RE: Nine Mile Point Unit 1
Docket No. 50-220
DPR-63

Subject: *Generic Letter 94-03, "Intergranular Stress Corrosion Cracking of Core Shrouds in Boiling Water Reactors," Request for Approval Under the Provision of 10CFR50.55a(a)(3)(i) for Modification of the Four Stabilizer Assemblies (Tie Rods) for Nine Mile Point Unit 1 (NMP1)*

ENCLOSURE 3

MODIFICATION FIGURES AND DESIGN STRESS REPORT

FIGURE 2 - UPPER SPRING

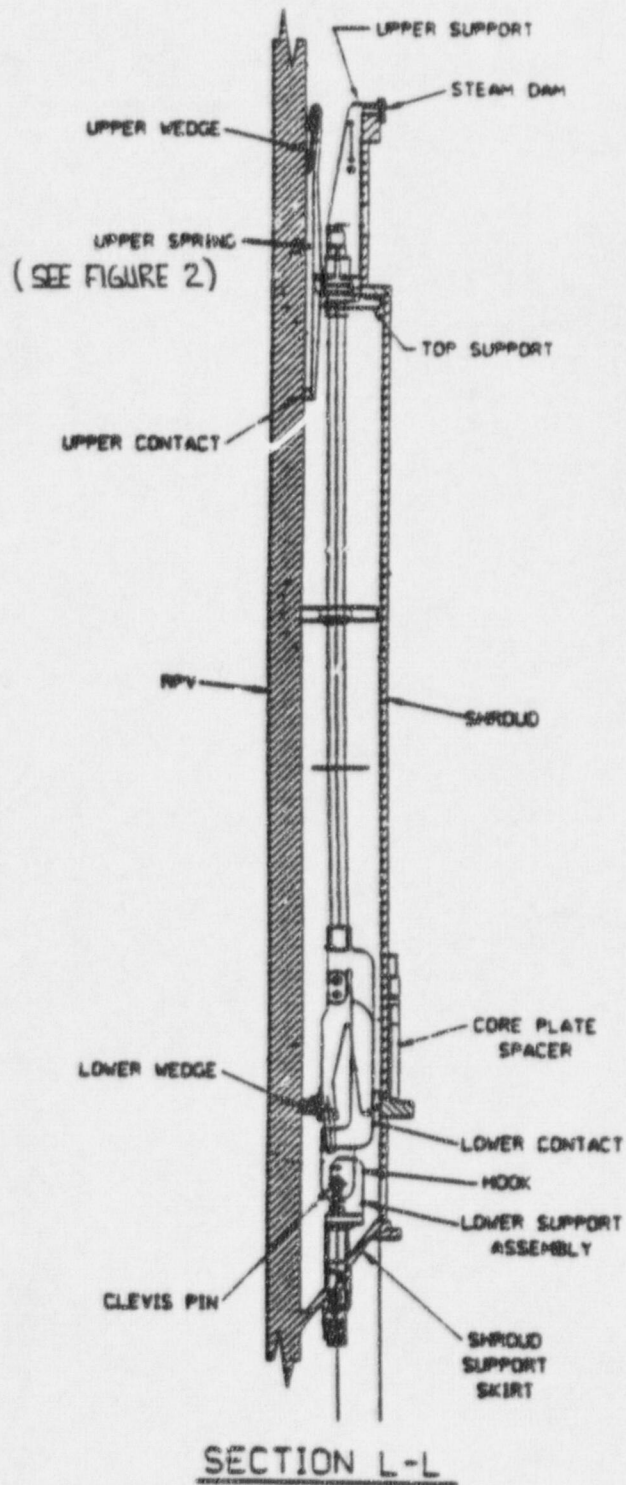
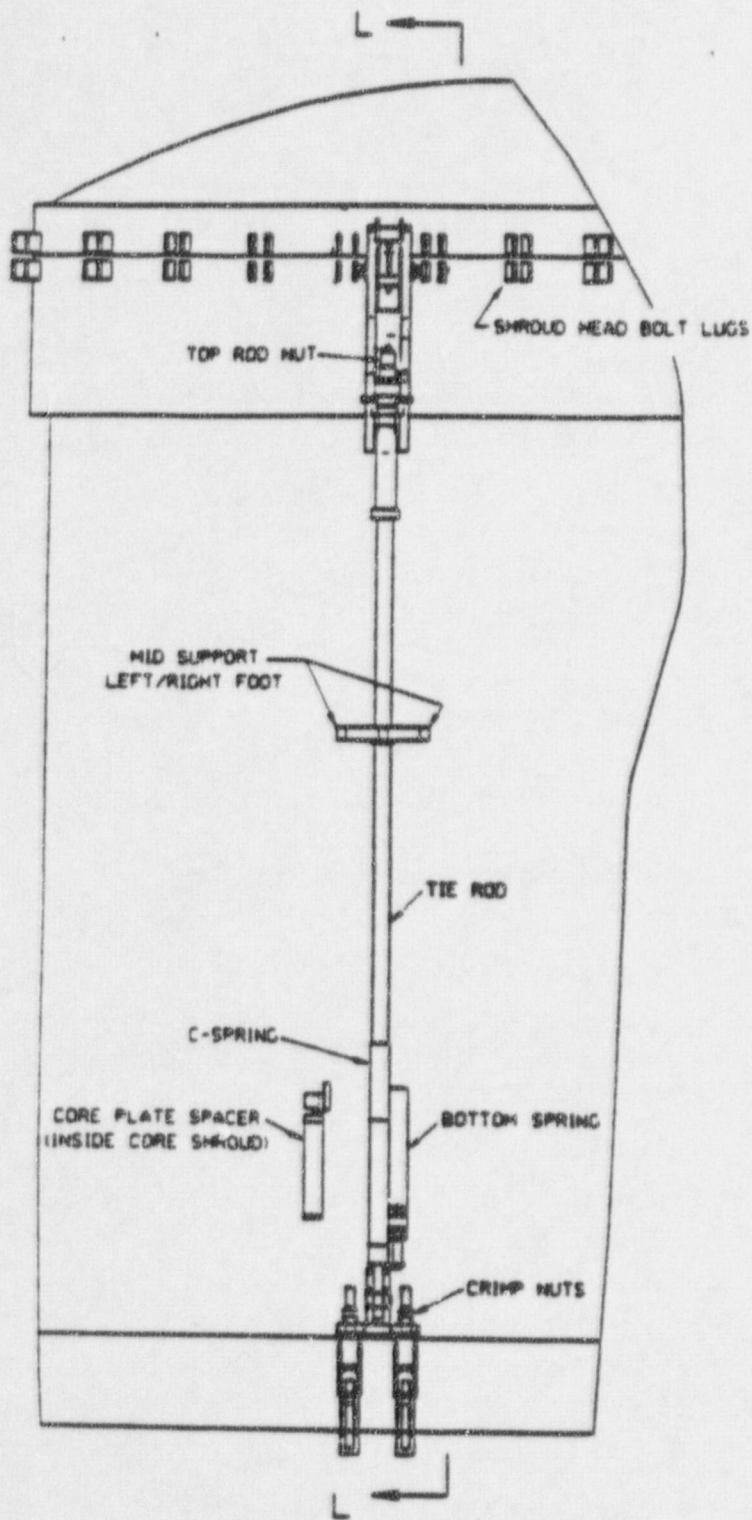
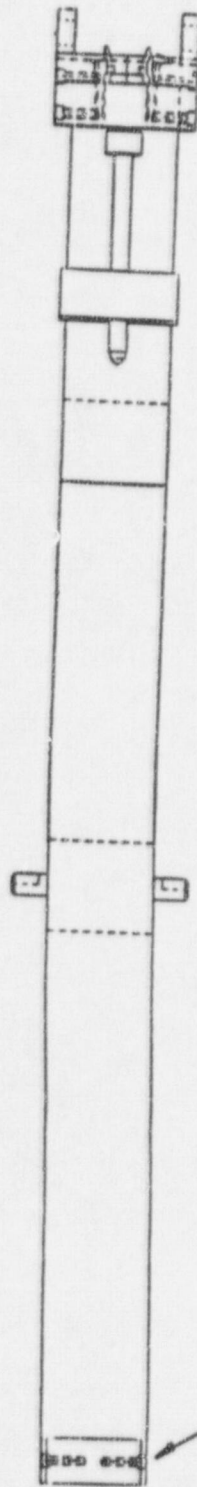
Accordingly, a proposed modification will replace the design function of the failed cap screw and other cap screws that have the potential for future failure. The modification includes changes to each end of the upper spring for each of the four tie rods. This proposed modification also contains provisions to prevent the creation of loose parts in the reactor vessel due to the potential for failure of the subject cap screws. In addition, the modification includes rounding off the

leading edges of the upper wedge and upper contact of the upper spring for the four tie rods as a preventative measure to reduce stresses on the tie rods and to reduce the likelihood of future wear on the cladding of the RPV.

SEE FIGURE 3
FOR REPAIR DESIGN

SEE FIGURE 4
FOR REPAIR DESIGN
